BRISTOL AEROSPACE LIMITED ENGINEERING MEMORANDUM

RELOCATION OF ADF SENSE ANTENNA
SYSTEM

15972

VIEW AA

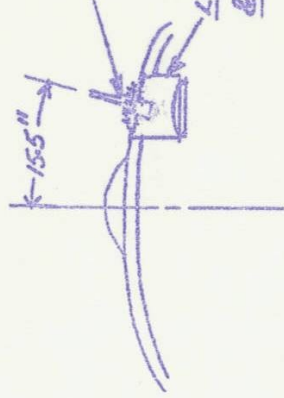
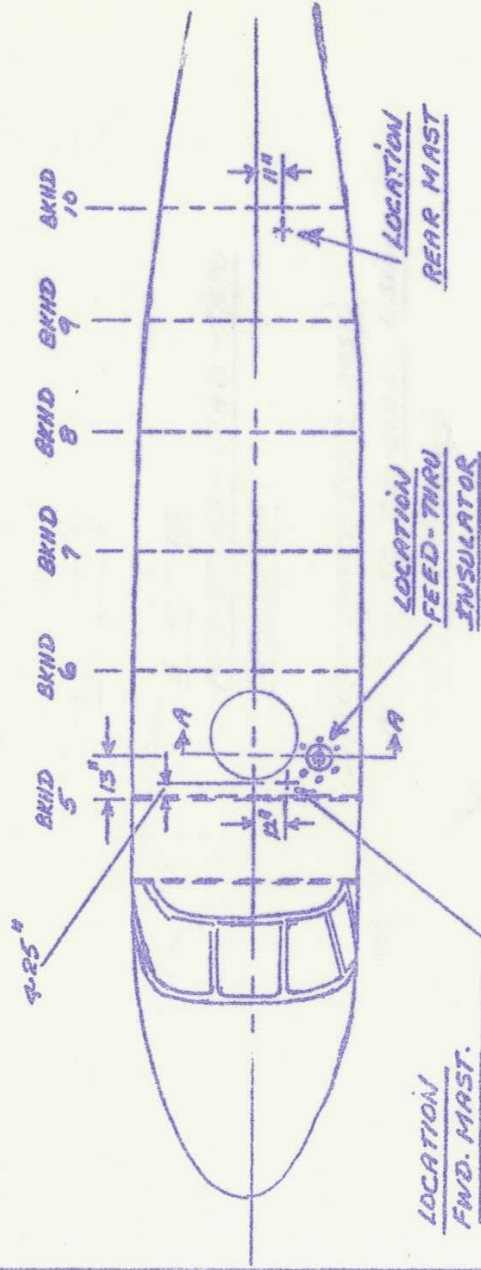
3. Relocate the Lead-Thru Insulator (Anstat 126-LI-100) as follows:

(a) locate and cut hole in skin to accept the lead-Thru Insulator, directly over the mtg. box for the l.h. fwd. cabin dome Lt (see sketch).

(b) install as per Sketch (shown on p. 2), using screws of the same type used for attaching the masts.

LEAD-THRU INSULATOR MTG HOLE REPAIR

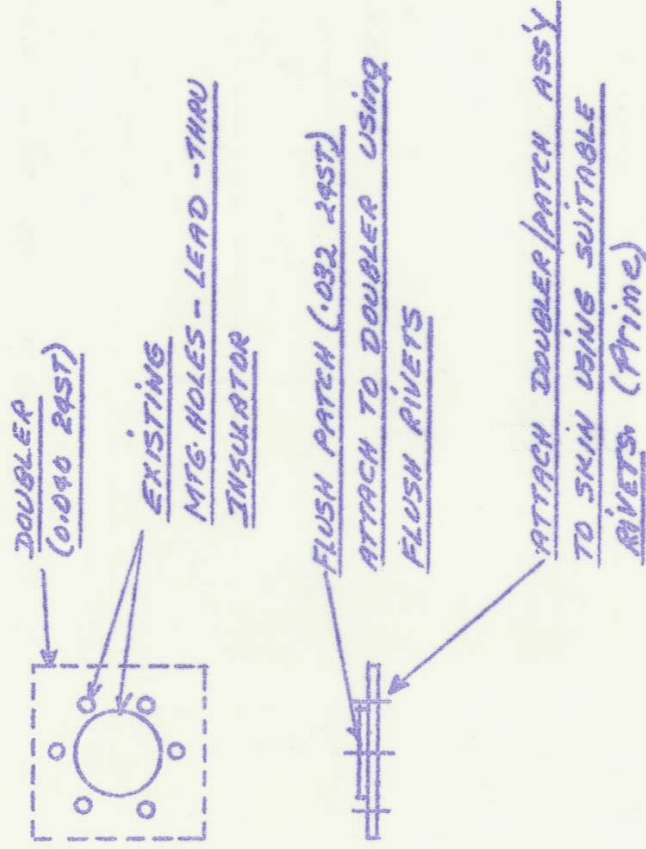
4. Repair the original mtg. hole for the lead-Thru Insulator as per sketch on p. 3.
